Initial Product/Process Change Notification

Document #: IPCN25336X

Title of Change:	Qualification Assembly site in UTAC Thailand for FSA2257L10X, FSA3157L6X, FSUSB11L10X, NC7SB3157L6X, NC7SZ66L6X
Proposed First Ship date:	30 Sep 2023 or earlier if approved by customer
Contact Information:	Contact your local onsemi Sales Office or Thomas.Chen@onsemi.com and Naruedol.Srisamran@onsemi.com
PCN Samples Contact:	Contact your local onsemi Sales Office. Sample requests are to be submitted no later than 30 days from the date of first notification, Initial PCN or Final PCN, for this change. Samples delivery timing will be subject to request date, sample quantity and special customer packing/label requirements.
Type of Notification:	This is an Initial Product/Process Change Notification (IPCN) sent to customers. An IPCN is an advance notification about an upcoming change and contains general information regarding the change details and devices affected. It also contains the preliminary reliability qualification plan. The completed qualification and characterization data will be included in the Final Product/Process Change Notification (FPCN). This IPCN notification will be followed by a Fin

Product material change description:

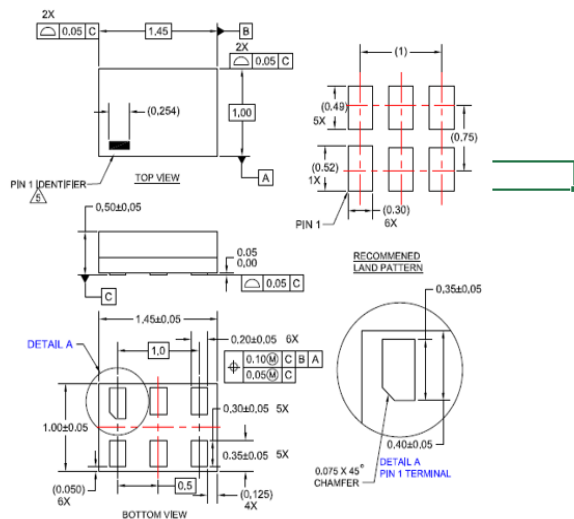
From	To
Assembly Site	HANA Thailand	UTAC Thailand
LeadFrame	No change	No change
Die Attach	DA FILM LI LE5003 P8AS 100ST	DAF HR5104
Bond Wire	No change	No change
Mold Compound	MC NITTO GE100LFCG 14MMX4.6G	Kyosera / KE-G1250LKDS-30 BU10C
Package Substrate	PS LGAB LOGIC KINSUS	FAST PRINT LGA SUBSTRATE
Carrier tape	Carrier tape for package thickness at 0.55 max & 0.65max	Carrier tape for package thickness at 0.68 max

• For FSA2257L10X, FSUSB11L10X

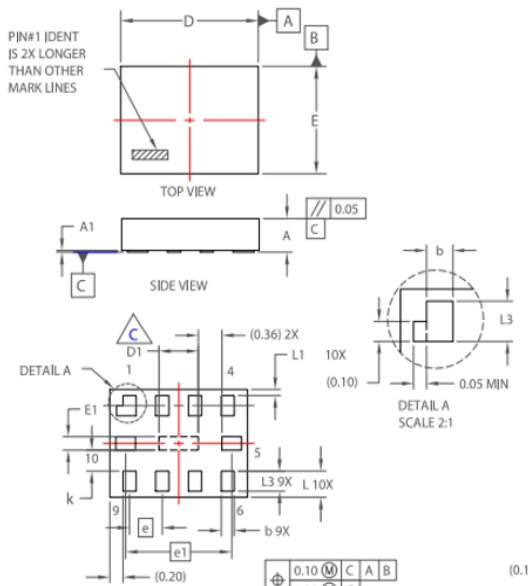
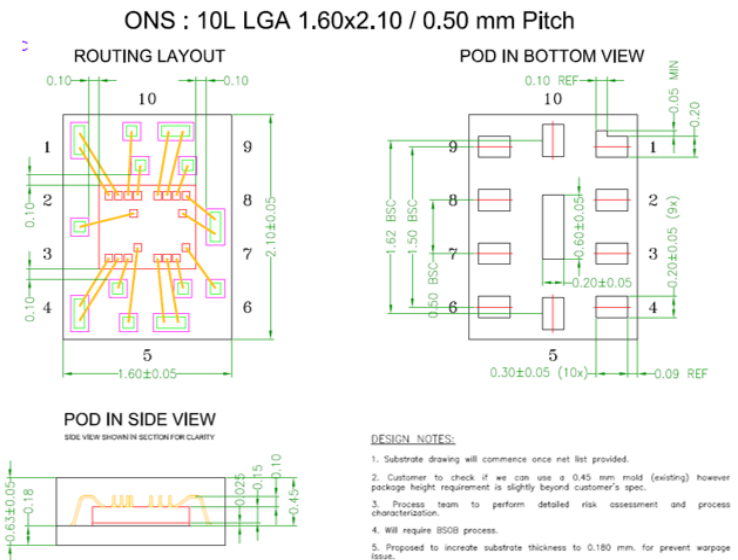
Dimension	HANA Thailand (existing)			UTAC Thailand (new site)			Remark
	Min	Nom	Max	Min	Nom	Max	
A	0.50	0.55	0.65	0.58	0.63	0.68	UTAC thicker than HANA
b	0.15	0.20	0.25	0.15	0.20	0.25	Same
D	2.00	2.10	2.20	2.05	2.10	2.15	Comply
D1	0.55	0.60	0.65	0.55	0.60	0.65	Same
E	1.50	1.60	1.70	1.50	1.60	1.70	Same
E1	0.15	0.20	0.25	0.15	0.20	0.25	Same
e	0.50 BSC			0.50 BSC			Same
e1	1.62 BSC			1.62 BSC			Same
L	0.25	0.30	0.42	0.25	0.30	0.42	Same
L1	0.00	0.09	0.15	0.09 REF			Comply
L3	0.25	0.30	0.35	0.25	0.30	0.35	Same
